**RE: Federal Register Notice: 2125-AF85, Document Number: 2020-26789
National Standards for Traffic Control Devices; the Manual on Uniform Traffic Control Devices
for Streets and Highways; Revision (USDOT/FHWA)**

From: Donald Kostelec – Boise, Idaho; don.kostelec@gmail.com

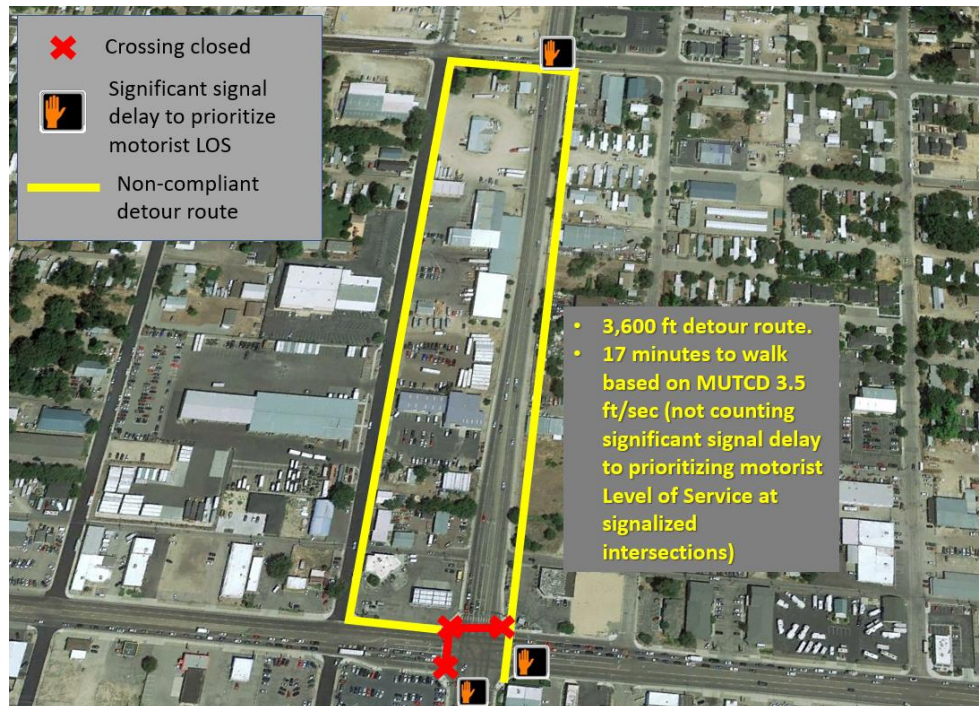
These video links show the issues when agencies do not apply a preemptive action in the programming of traffic signals.

- Video 1, Boise Ave and Apple Street, Boise, ID – Boise School District Special Education Group Crossing at the Walk Signal while motorists have a FYA: https://youtu.be/7x_XY9UBz2M
- Video 2, US Highway 91, Pocatello, ID - <https://youtu.be/ylAmWh8FOUM>
- **Recommendation:** MUTCD include this preemption practice as guidance and one that is stated as a **standard** when marked and signalized pedestrian crossings are present in urban areas, a school zone (time specific programming), and other land uses with notable pedestrian and bicyclist trip generation or trip generating potential.

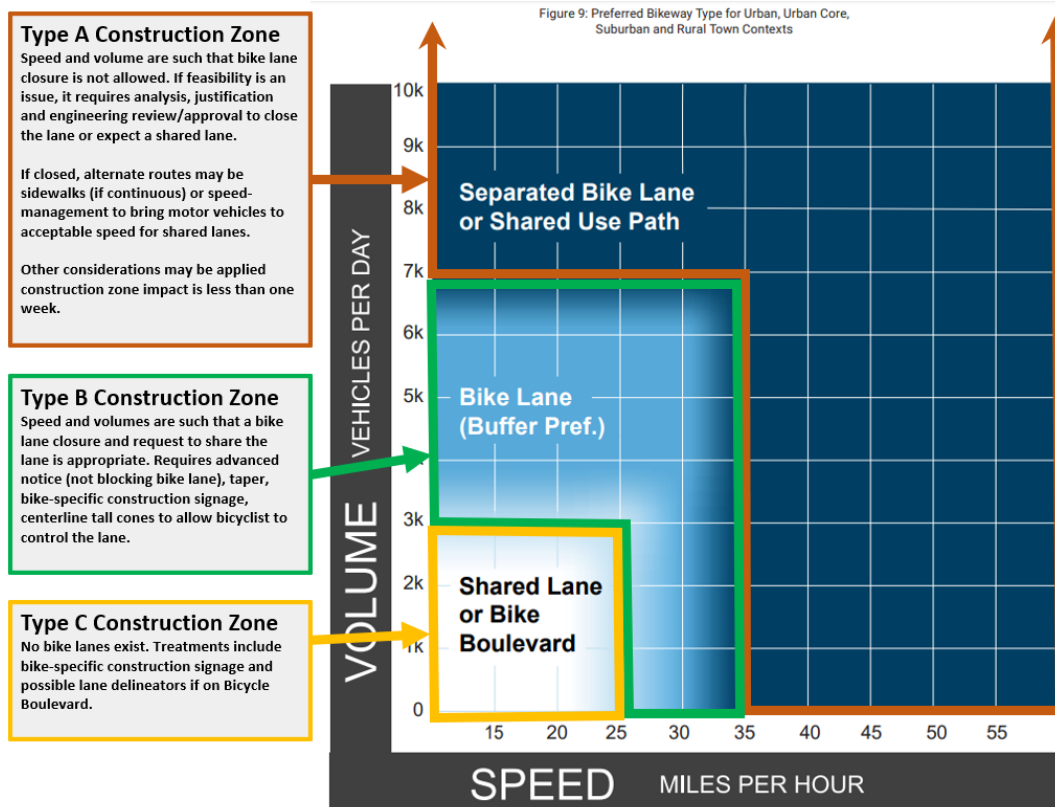
- **Recommendation:** Include standards and guidance in Section 6 for APS to be programmed to identify street closures and detour routes. Identify other factors for deactivating APS or pedestrian signal heads when these closures occur.
- **TTCs for Bicyclists:** Section 6 needs a section on specific temporary traffic controls for bicyclists, similar to what exists for pedestrians in Section 6C.

One of my common experiences in bicycling and leading efforts for bikeway planning and design is construction zones that force bicyclists who had a dedicated bike lane or a protected lane pre-construction to then share the lane with vehicles. This is often done without consideration to context of the street.
